PROPOSED SITE IMPROVEMENTS  
TO  
SHELL GAS STATION

375 MAIN STREET  
ARMONK, NY

September 14, 2020  
**VIA E-MAIL**

Re: ***375 Main Street – Site Plan Approval  
Section 108.03, Block 1, Lot 75***

DRAWING TITLE:  
**PROPOSED SITE PLAN**

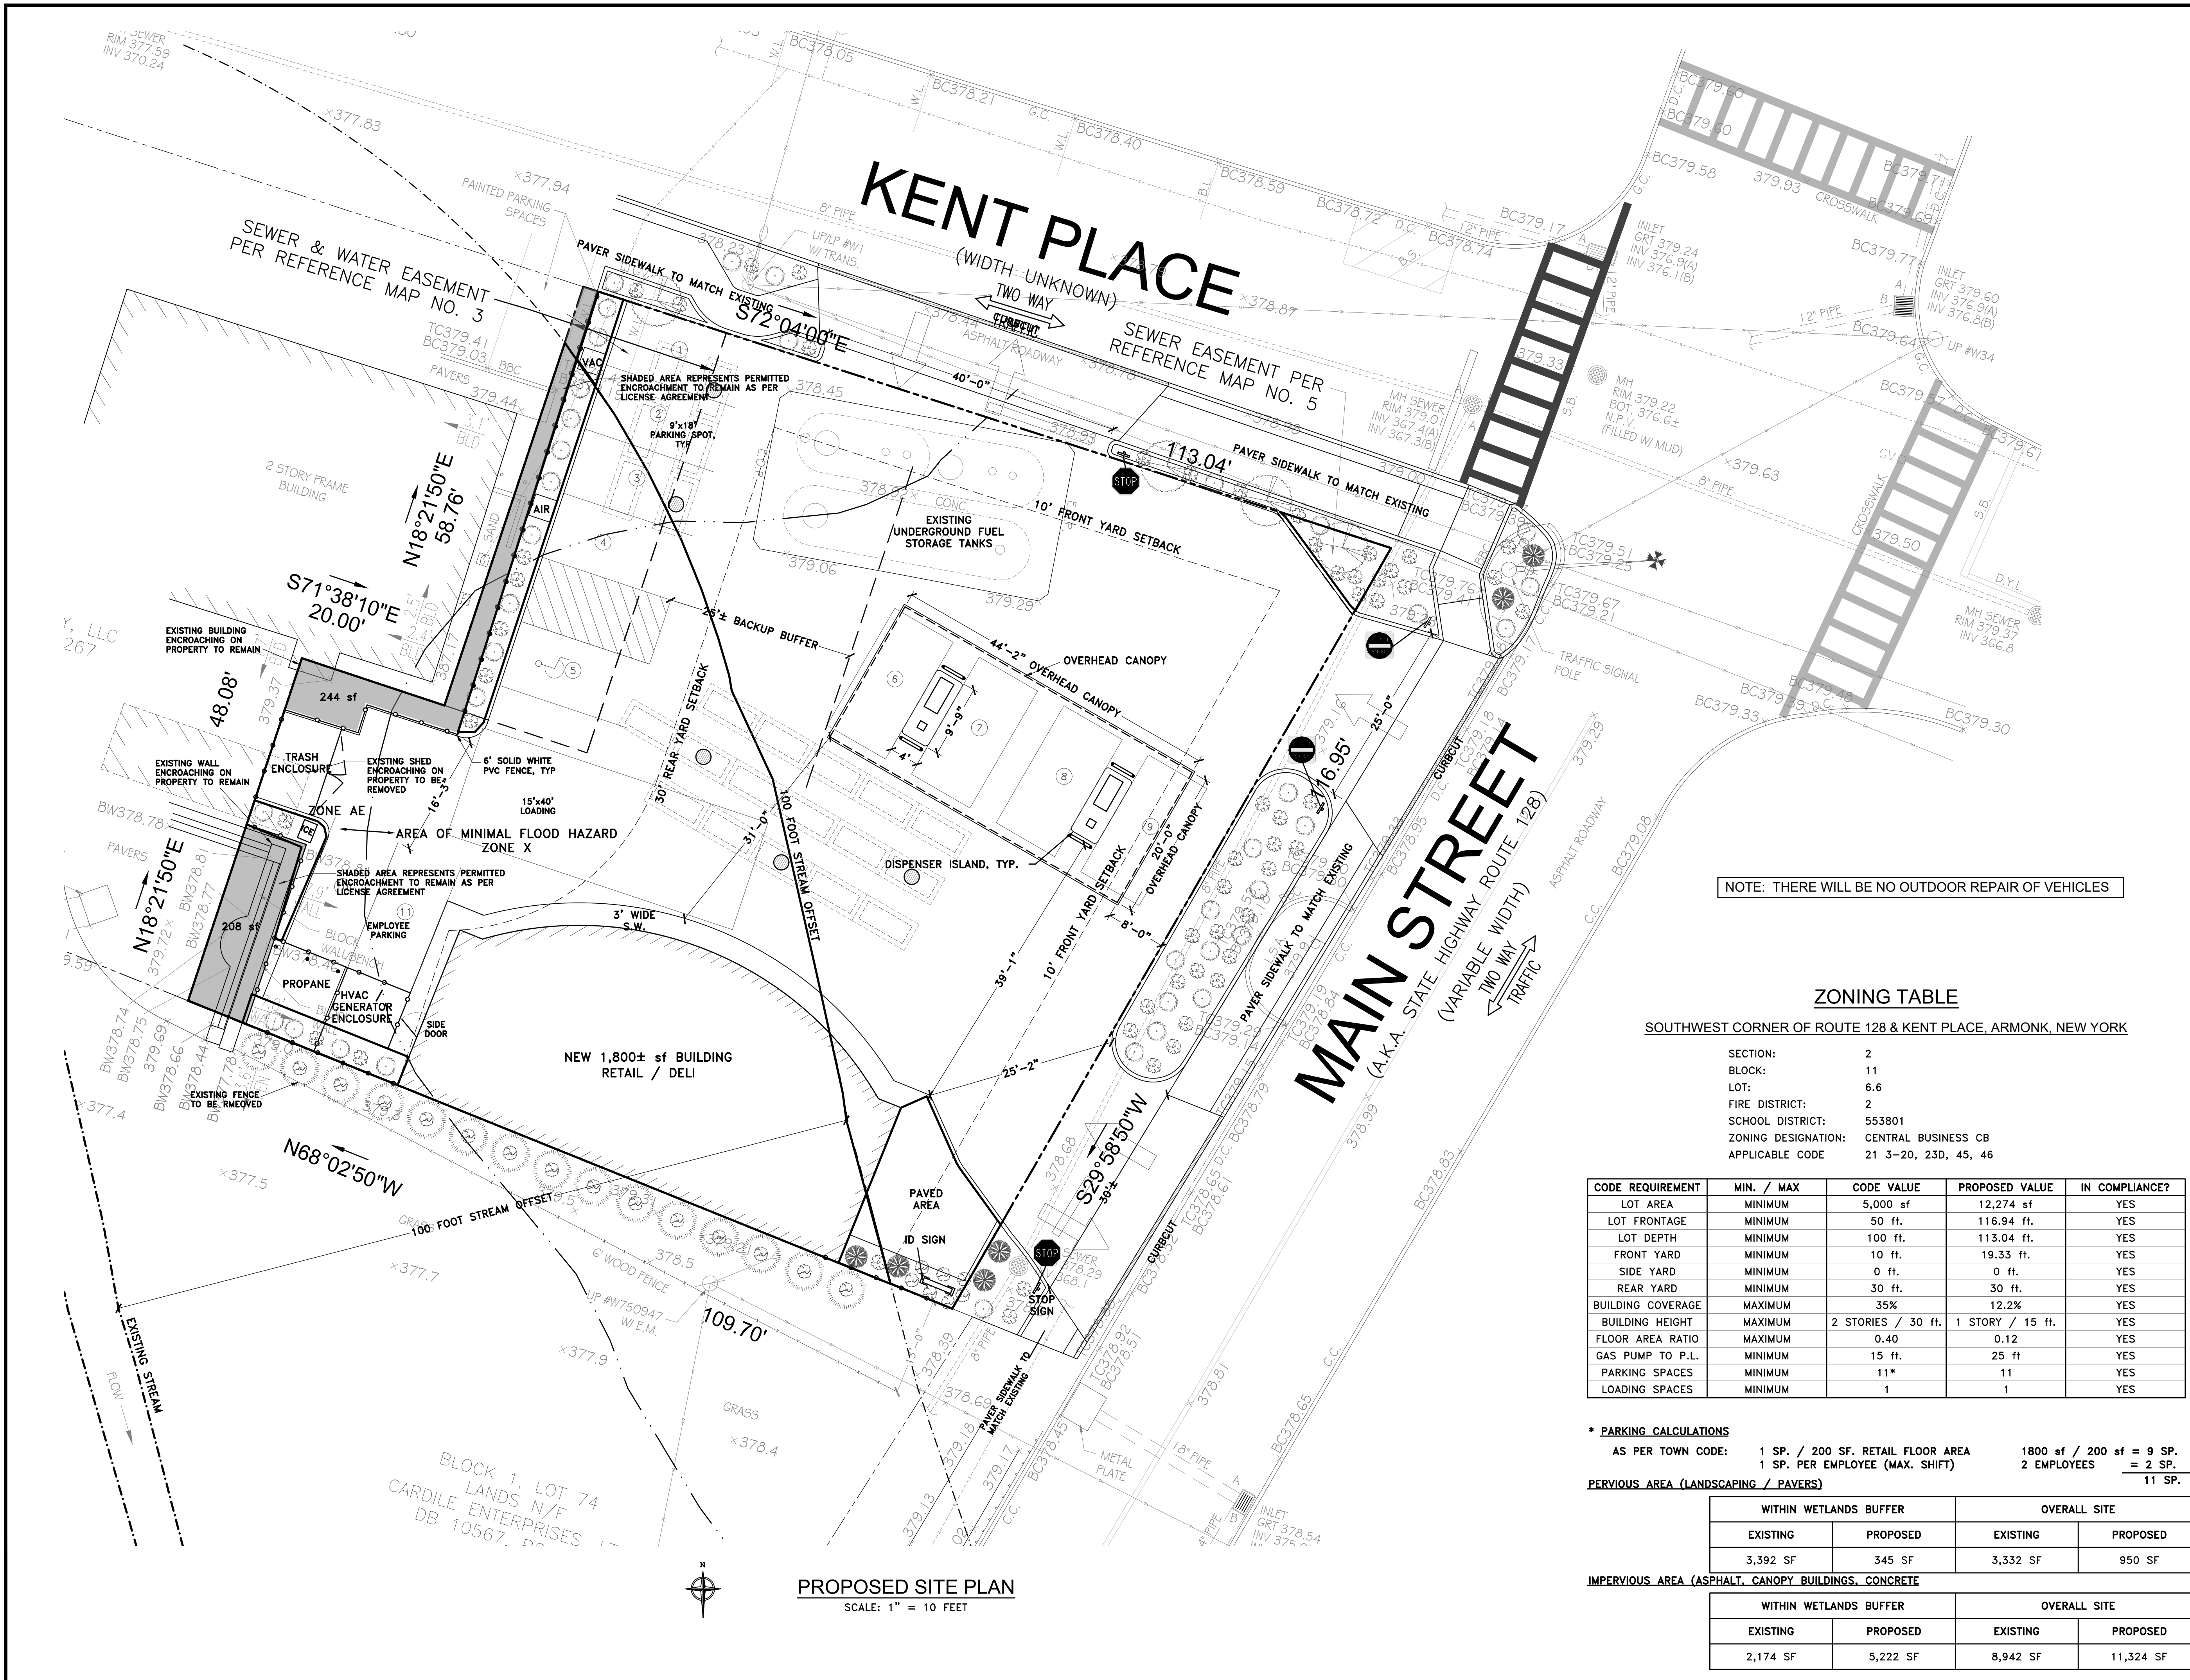
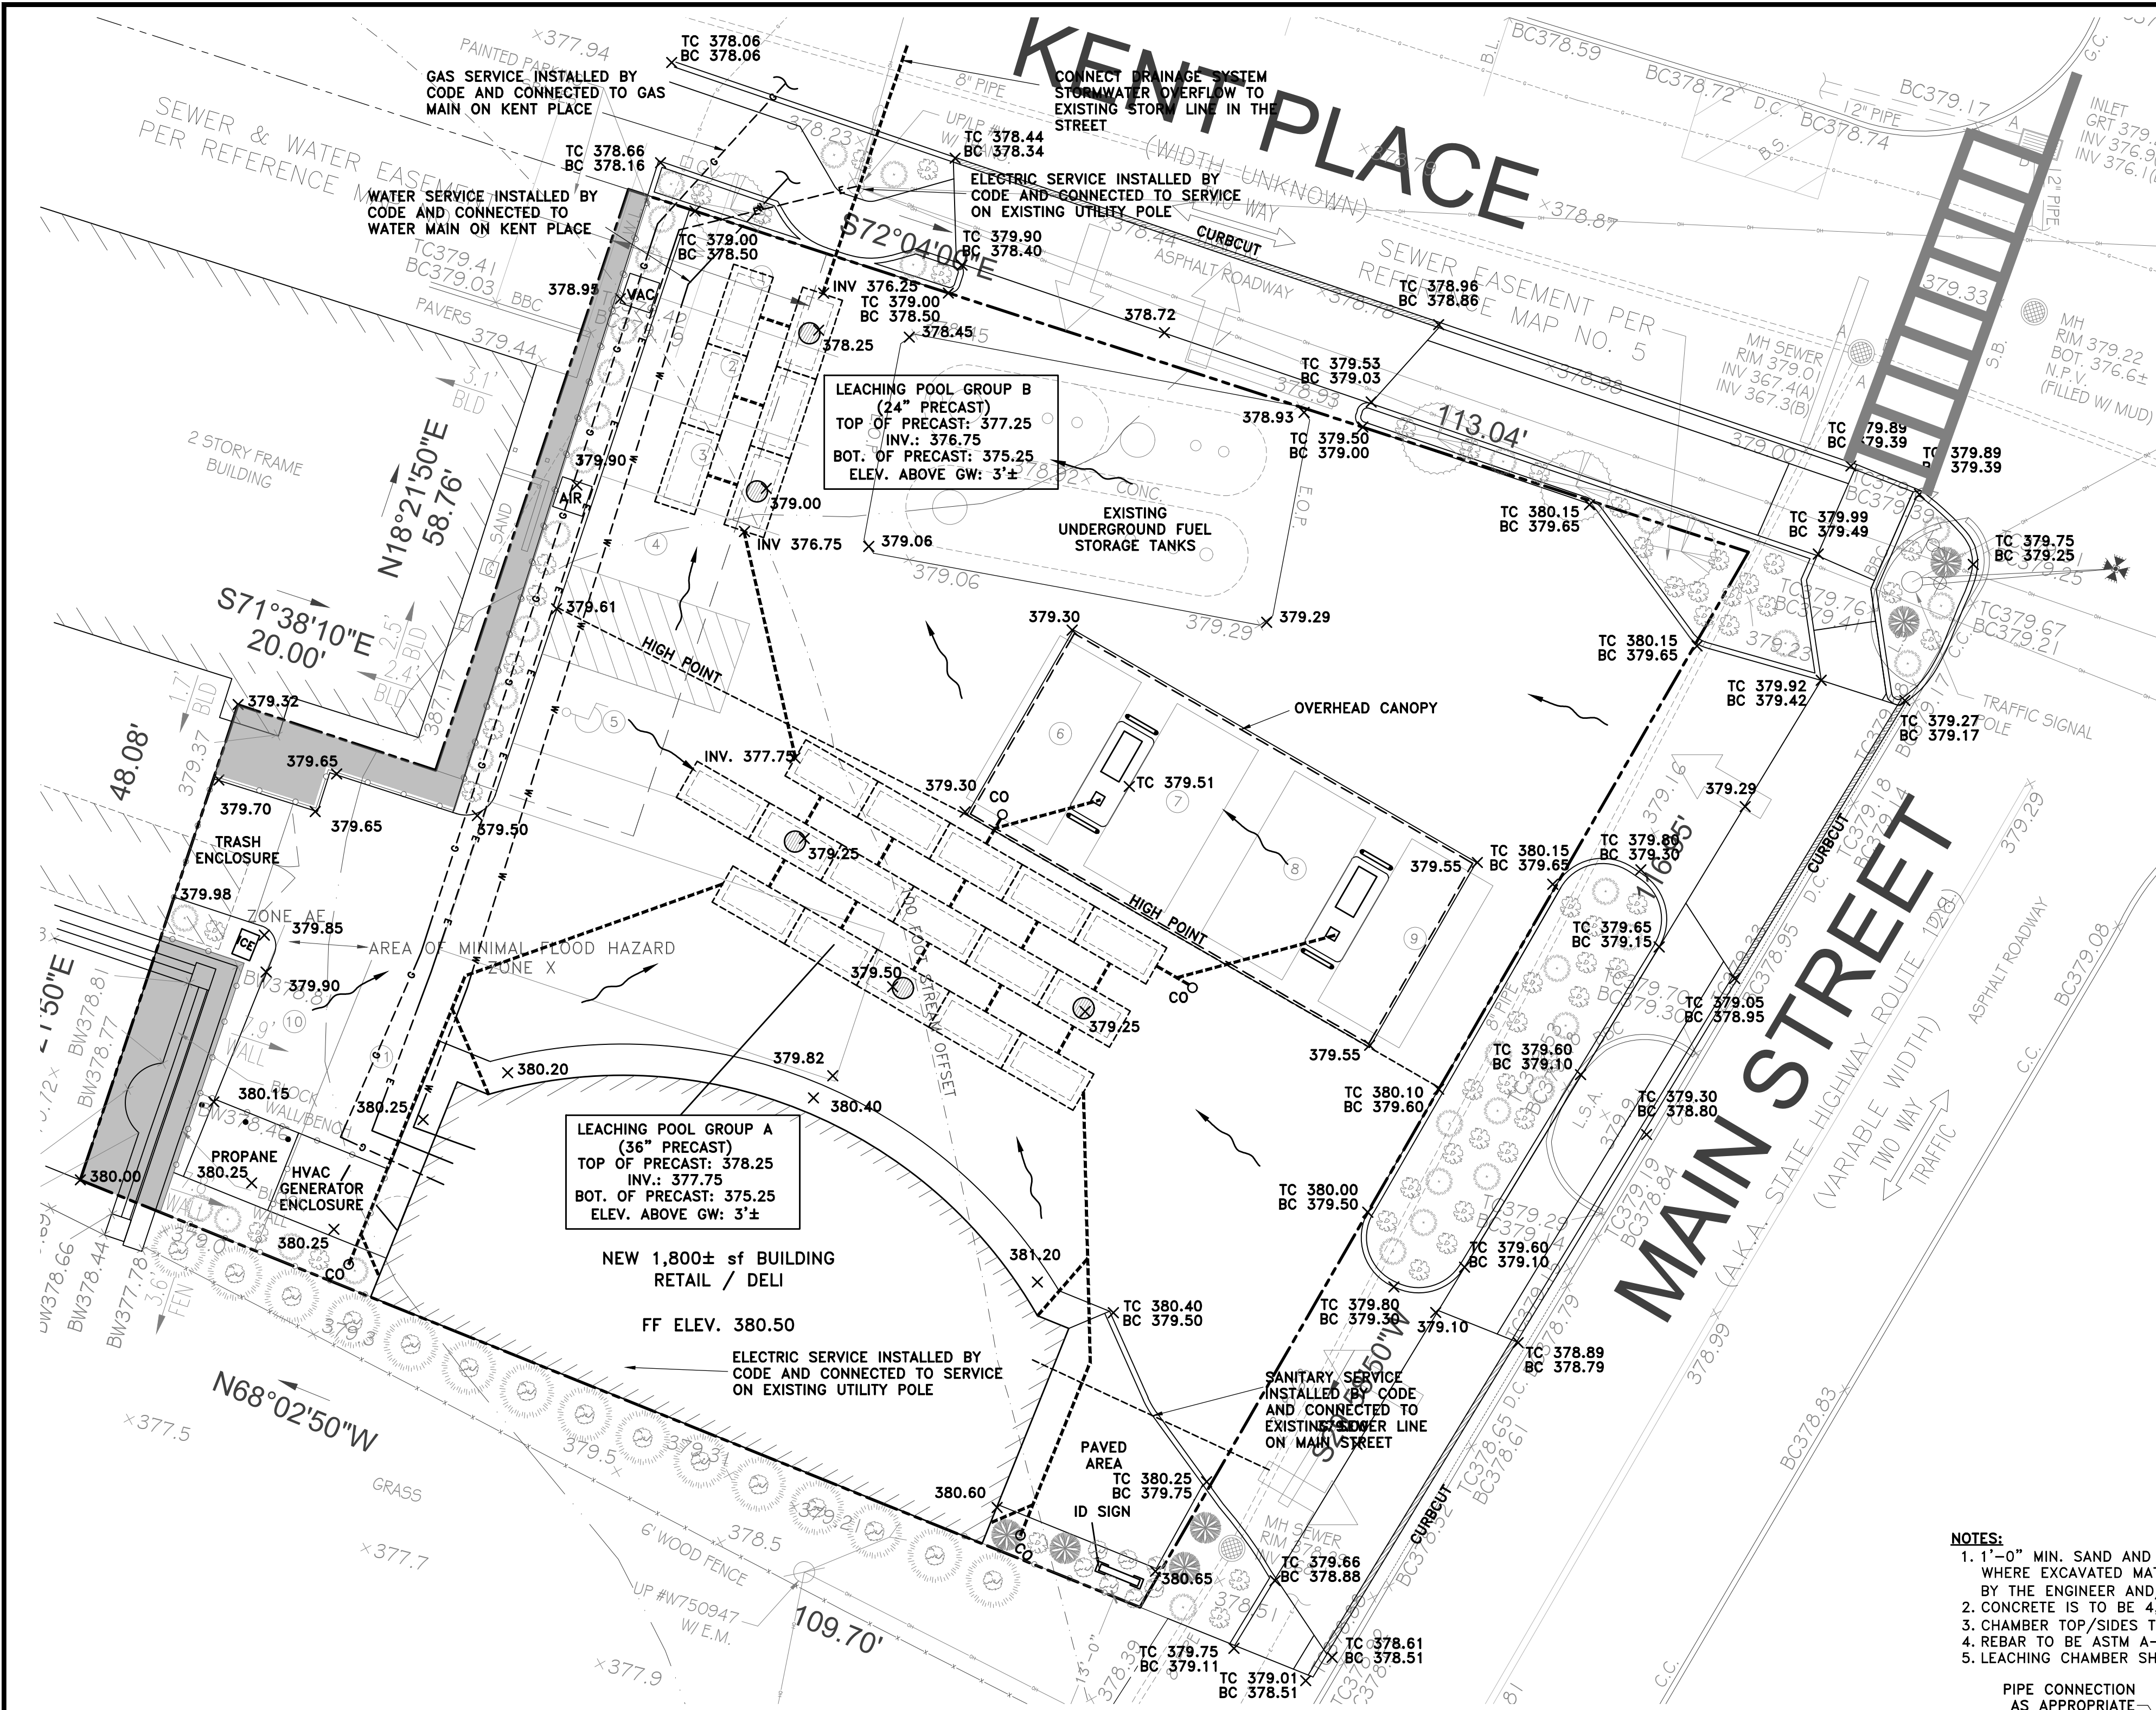
The planting strip along the edge of the parking area, trash enclosure, propane and HVAC enclosures have all been modified to accommodate the continuance of the existing encroachments from 1 Kent Place. The fuel pumps have been set back 15-feet from Main Street and the canopy has been set so as not to encroach closer than 8-feet to Main Street (the Applicant has confirmed this is a permitted encroachment with the Building Inspector).

The new sidewalk design along Kent Place has been revised to avoid impacting the existing utility pole and will utilize the same paver design that is utilized in the existing sidewalks on the opposite side of Kent Place and Main Street. The freestanding ID sign location is now within the property boundaries. The location of the side door to the building is now depicted on the site plan. The gravel picnic area has been replaced with a paved surface for easier maintenance.

The Applicant has revised the proposed plans to make the northerly curb cut on Main Street ingress only. This will allow southbound vehicles on Main Street to enter the site and pull directly into a fueling position without having to pass in front of the convenience store; however, it eliminates egress from the site in close proximity to the intersection. We note that the Town's traffic consultant only recommended that this curb cut operate with right-turn egress only - - the Applicant has gone a step further and eliminated egress from this curb cut altogether.

As shown on the revised site plan, the radius at the southwest corner of the intersection of Main Street and Kent Place has been increased to improve maneuverability while maintaining the existing traffic signal pole. The crosswalk spanning Kent Place will be restriped in kind by the Applicant in coordination with the Town Engineer and Highway Department.
